From: Matt Philpott <[REDACTED]@[REDACTED].au>
Sent: Monday, 25 November 2019 4:23 PM
To: IPCN Enquiries Mailbox
Cc: Bradley James; Matthew Somers; Ric Peterson; [REDACTED] Rose, Rod
Subject: [WARNING: ATTACHMENT UNSCANNED]Mundamia subdivision - Slope Analysis and Additional Bushfire Information - Attention: Bradley James - N25489
Attachments: 2016-01-27 - Rod Rose - [REDACTED] - Amanda Moylan, martha.dotter@rfs.nsw.gov.au, Matt Philpott - 25489 - Mundamia subdivision.msg; Mundamia; Response to IPC on bushfire

From: Rod Rose [REDACTED]
Sent: Wednesday, 27 January 2016 2:50 PM
To: Amanda Moylan; martha.dotter@rfs.nsw.gov.au
Cc: Matt Philpott
Subject: Mundamia subdivision
Attachments: APZ_20150521.png; APZ_20150319_v2.pdf

Our client for the Part 3A Development for Preferred Project Report - 30//1198692 - George Evans & Jonsson Road, Mundamia has asked us to clear up the APZ and slope issues to the NE and East referred to in your letter dated 10th September 2-15 (Your Ref: D15/2555, DA15082898296 MD). As it is not clear where your differences in calculation of the slope come from can we discuss this please?

Asset Protection Zones

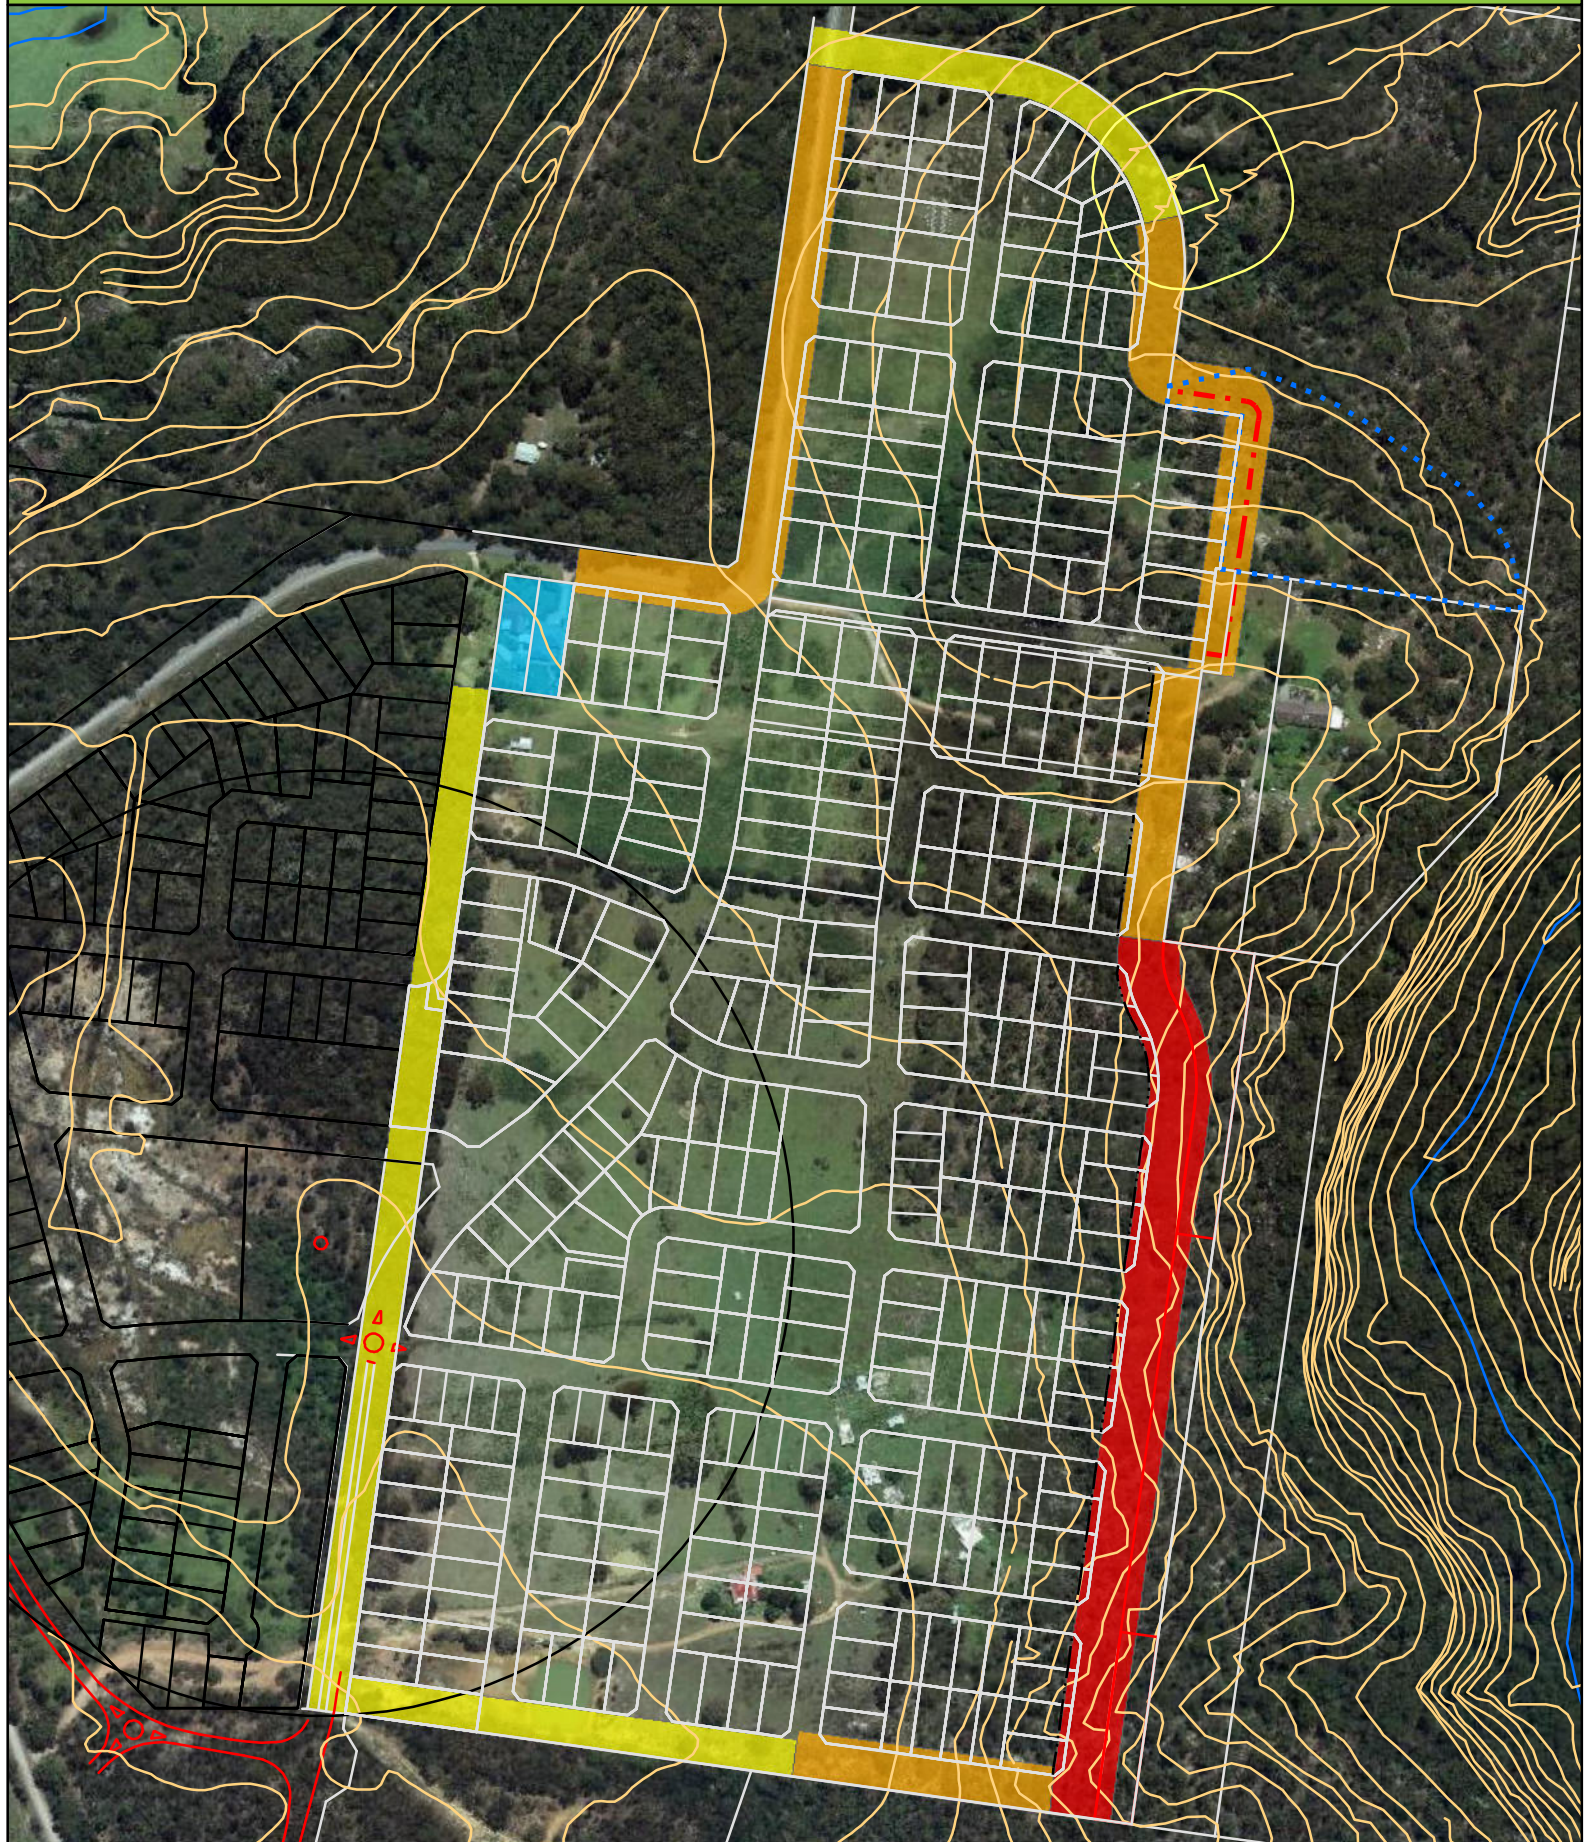
Detailed GIS slope analysis using 2 m contours was undertaken along the south-eastern boundary. 11 transects of 100 m each were used to determine the effective slope, with the slope ranging from 1.1° to 8.8° downslope. The steepest slope of 8.8° (rounded up to 9°) was used to model the width of the required APZ.

The contours used in our assessment were obtained from surveyor provided 2m contour data, and analysed in ArcGIS through point to point measurement. It is accepted that this measurement process in some cases relies on the GIS extrapolating heights between contours, however is also a limiting factor in manual methods i.e. estimating the height of a point between contours. GIS provides a reasonable algorithm to determine slope from point to point whereas manual methods are pretty much guesswork. Nevertheless a conservative approach was utilised in our work applying the steepest slope of the 10 transects when for the SE portion and many of the transects had lower slope grades (see slope data in Table below). Whilst steeper slopes occur beyond the 100m slope assessment line (measured 100 m out from the green line which represents the building line of the development, also attached is a clearer copy of the contour data) these steeper downslopes are either short in length i.e. 20 -50m, and therefore will NOT be the effective slope when >100 m from the building line (this can potentially be demonstrated with view factor modelling if required) or the steeper slopes are considerably further than 150 m away as in the SE portion of the boundary survey. NB: the attached contour map can be enlarged for more accurate measurement.

Both the manual and GIS methods of slope assessment provide a similar maximum slope to the south-east of the property on Transect 6 (i.e. 8.8° and 8.5° respectively). As our report utilises 9° this is considered conservatively appropriate as it is nearly three degrees higher than the average of slopes on the eastern side of 6.2° and is higher than the highest recorded effective slope. Furthermore, the highest recorded effective slopes only exist associated with narrow gullies or small cliffs (evident on site) and it can be argued with reasonable science/expert judgement that that these small cliffs and narrow bolder-filled gullies will reduce fire intensity not increase them.

If a higher effective slope of say 10 degrees was to be used in the APZ calculations the height differential over 100 m would need to be 18 m and there is clearly no place in the 2 m contour data that shows 9 * 2m contour intervals.

Slope

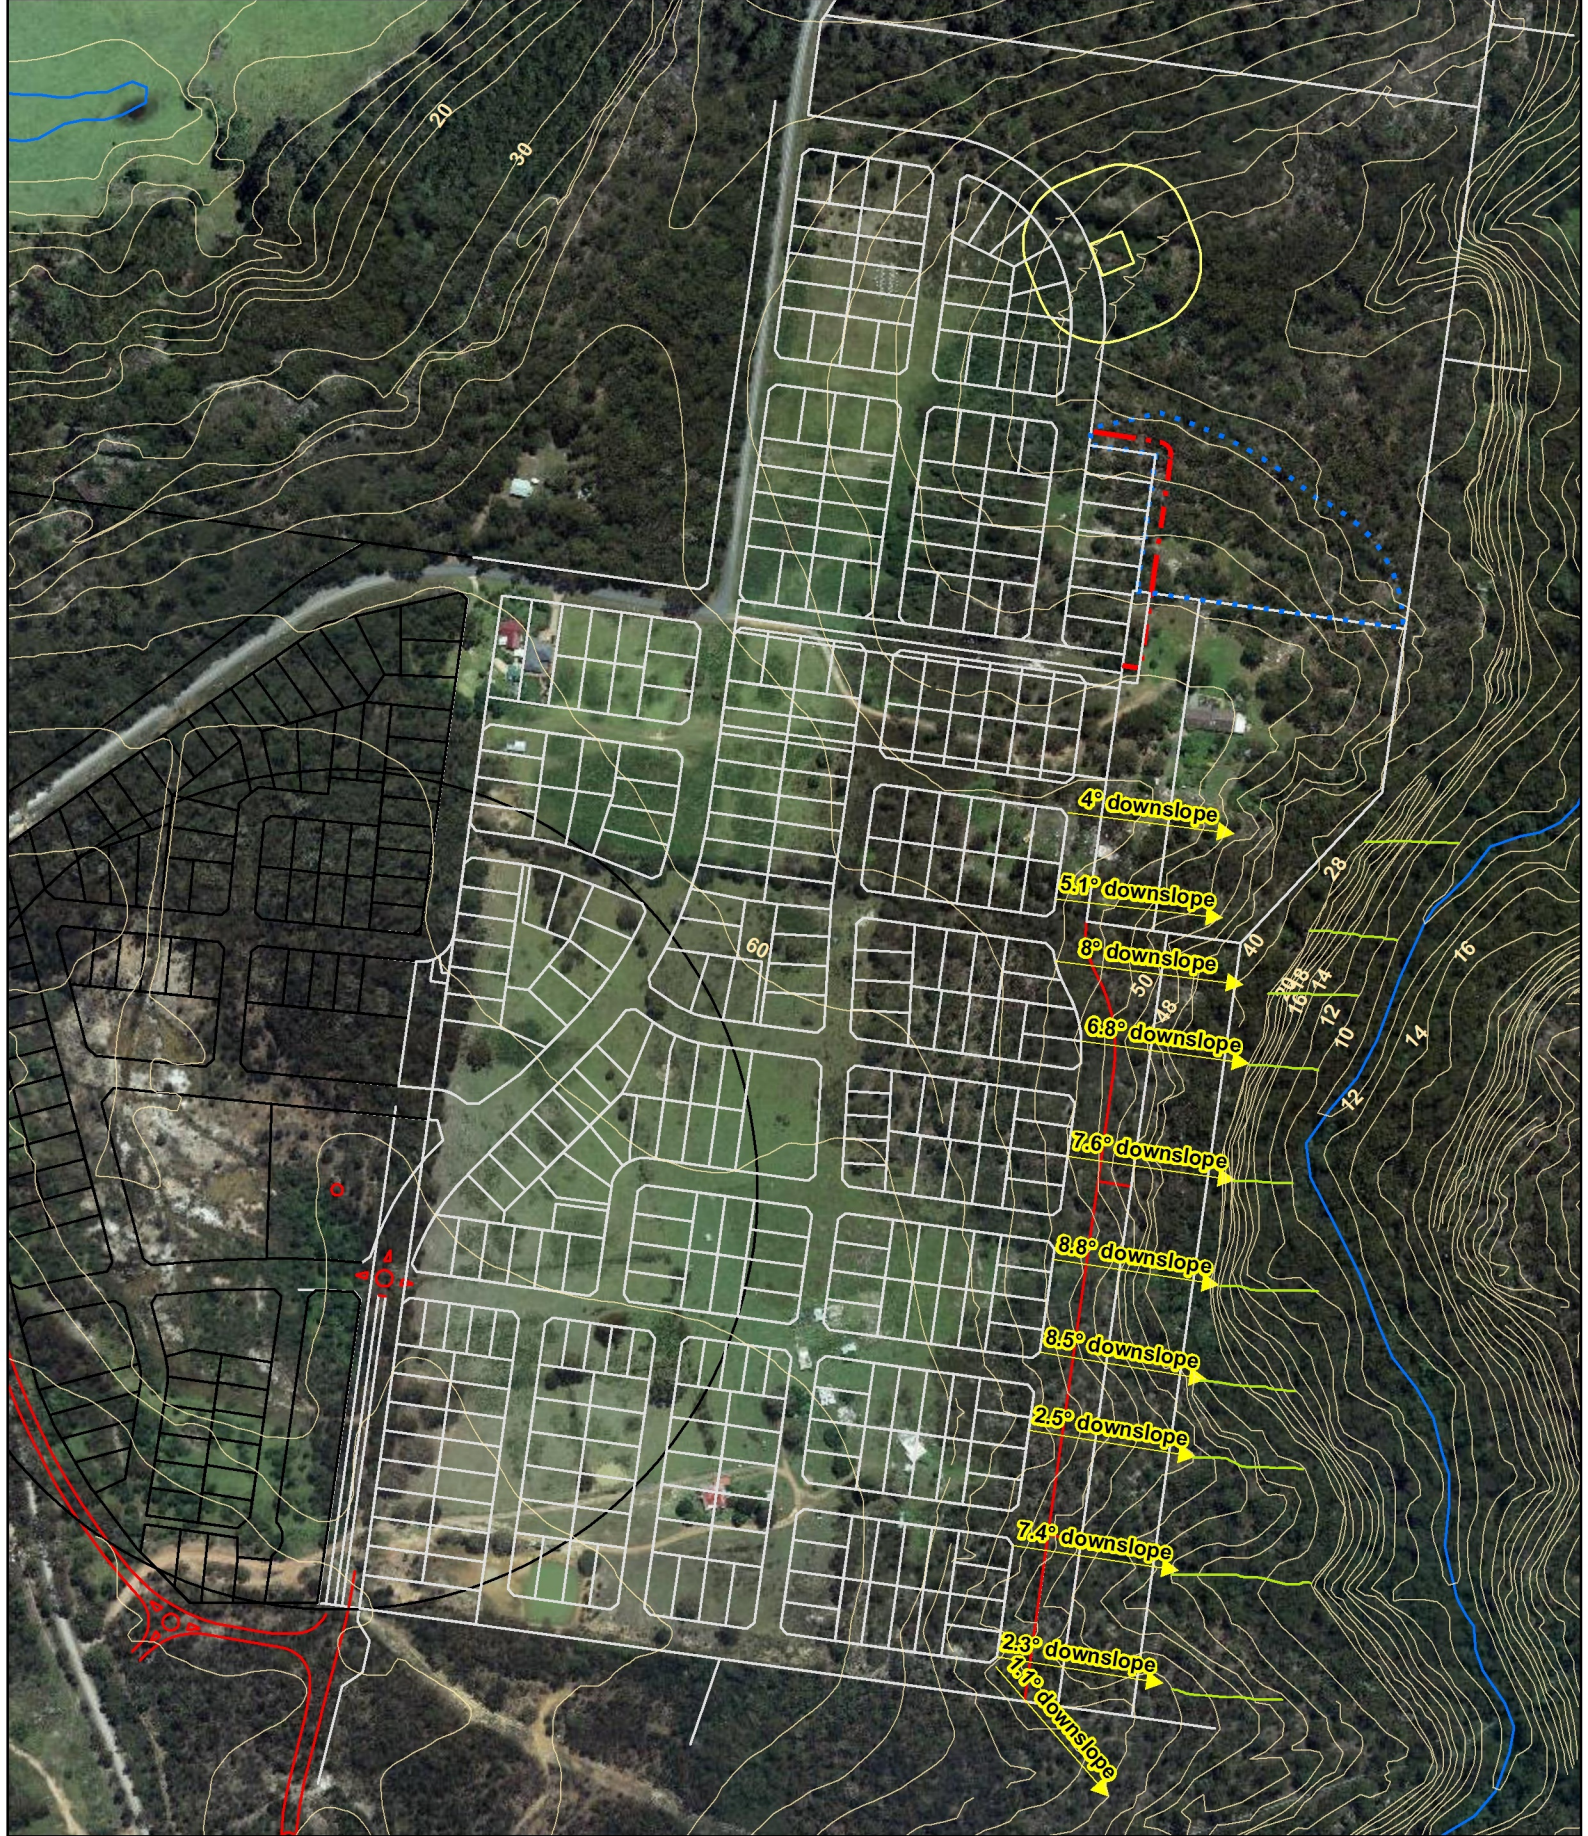
We have completed the additional slope analysis requested (i.e. analysis of slopes out to 150 m from the building line). As predicted the highest radiant heat flux resulting from the steeper slopes produces a RHF of 17 kW/m² well under the 29 kW/m² achieved with the more gentle slopes nearer the development (see attached modelling report, using the slopes from the nine 50 m transect extensions shown in green in the attached Figure). These results occur because radiant heat decreases exponentially with distance and although steeper slopes may produce higher intensities this is overshadowed in this instance by the increased separation distances.

It is also my expert judgement (as a former FCO within Shoalhaven City and having managed over 1600 bushfires) that the short lengths of steeper slopes beyond 100 m will not result in fire intensities that will carry through any distance of consequence within the APZ. The steeper slopes are often 20 m or so in length and covered in a heavy rock cover on average about 25% of ground surface and >30% of surface within 50 m nearest the building line (see example photographs showing rocky escarpment creating most of the average slope issues), this rock cover and the short length of slope up from the bottom of the watercourse (see final photo) significantly mitigates fire spread and intensity. These site conditions and the exponential decrease in radiant heat with distance means the steeper slopes beyond 100m are NOT the effective slope.
